Technical Service Bulletin (TSB)

Engine Overheat

REFERENCE:	TSB: 07-006-26 REV. A GROUP: 07 - Cooling	Date:	September 1, 2026	REVISION:	07-006-26
VEHICLES AFFECTED:	2026 - 2027 (DJ) RAM 2500 Pickup 2026 - 2027 (D2) 3500 Pickup 2026 - 2027 (DD) RAM 3500 Cab Chassis 2026 - 2027 (DP) RAM 4500/5500 Cab Chassis This bulletin applies to vehicles built on or after **February 21, 2026 (MDH 0221XX) and on or before July 22, 2026 (MDH 0722XX)** equipped with 6.4L V8 Hemi Upgrade HD Engine (Sales Code ESL).			MARKET APPLICABILITY: ☒ NA☒ MEA ☐ EE☐ IAP ☒ SA☐ CH NOTE: This bulletin applies to the North America, South America and Middle East & Africa markets.	
CUSTOMER SYMPTOM:	Customers may comment on the following: - Vehicle overheating. - Temperature gauge is reading hot. - Overheat symbol is illuminated in Instrument Panel Cluster (IPC).				
CAUSE:	Thermostat

This bulletin supersedes Technical Service Bulletin (TSB) 07-006-26, date of issue August 21, 2026, which should be removed from your files. All revisions are highlighted with ****asterisks**** and include updated vehicle build dates, an updated Repair Procedure and a new Repair Procedure note.

Fig. 1
Thermostat Part Number Location

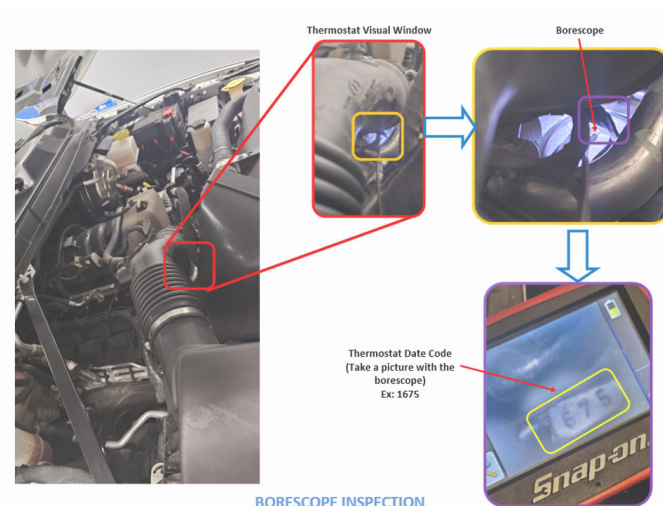
1. **Check the thermostat date code using a borescope and take a picture of the date code [Fig. 1](#), [Fig. 2](#).

2. Does the thermostat have a date code of **3375** or **3365**?
 - YES>>> Proceed to [Step 3](#).
 - NO>>> This bulletin has been completed. Use Inspection LOP (07-40-01-95) to close the active RSU.
3. Replace the thermostat. Refer to the detailed service procedures available in DealerCONNECT/Service Library under: Service Info> 09 - Engine, 6.4L / Engine Cooling / Thermostat / Removal and Installation.**
